ALTERNATIVES EVALUATION REPORT LOWER ALAMEDA CREEK/BART WEIR FISH PASSAGE ASSESSMENT

December 14, 2006

B COMMITTEE REVIEW COMMENTS

Figure 1 – Extended Fish Ladder Alternative

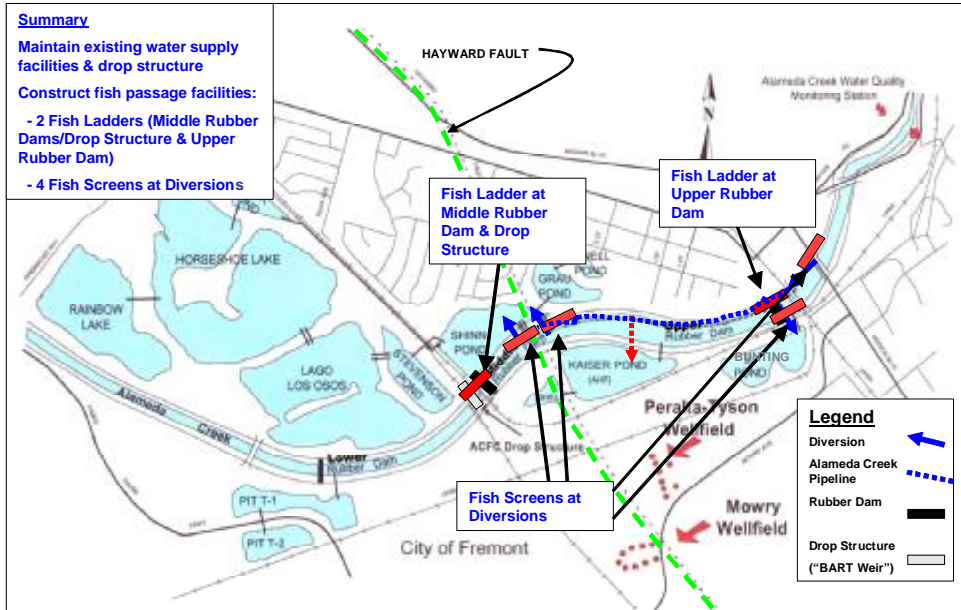
4. ACWD planning considerations for Middle Rubber Dam passage alternatives: ACWD is currently evaluating various alternatives for fish passage at the Middle Rubber Dam, including: (1) an extended fish ladder that provides passage past both the BART Weir and Middle Rubber Dam (see Figure 1, evaluated as the "Extended Vertical Slot" alternative in the draft BART Weir Passage report,); and (2) re-operating the Middle Rubber Dam such that it is deflated during the winter/spring migration period (see Figure 2, evaluated as the "roughened channel" and "reduced vertical slot" alternatives). The "re-operation" alternative

- a. Redundancy/reliability: The extended fish ladder alternative will provide ACWD with two operating rubber dams (and associated screened diversions) throughout the year. Given the proximity of Hayward Fault to these facilities, this is an important consideration for ACWD. With the potential failure of one dam, the other dam could still be utilized for water diversions through screened intakes. In addition, routine maintenance of ACWD's facilities above the Upper Rubber Dam (as well as other in-channel projects, such as the recent Mission Bridge project) may require that ACWD keep the Upper Rubber Dam deflated for a long period. Without the use of the Middle Rubber Dam and associated diversions (as considered under the re-operation alternative), this may have a significant impact on ACWD's water supplies.

- b. Operational flexibility: Maintaining two rubber dams operational throughout the winter and spring months (i.e. the extended fish ladder alternative) would also maintain existing operational flexibility for water supply operations. For instance, water could be supplied through screened diversions to the Quarry Lakes recharge pits via the Upper Dam, Middle Dam or both. In addition, maintaining the two rubber dams operational during the winter/spring would improve ACWD's capability to recharge water under high flow conditions. This operational flexibility may also provide benefits for fish passage. For instance, under certain conditions, a potential operating scenario after a high flow event may be to inflate the Middle Rubber Dam first, followed by inflating the Upper Rubber Dam at a later time. Under this operating scenario, a window of opportunity may be provided such that in-migrating steelhead would only need to pass through one fish passage facility in the flood control channel (the extended fishway), in order to access the upper watershed.
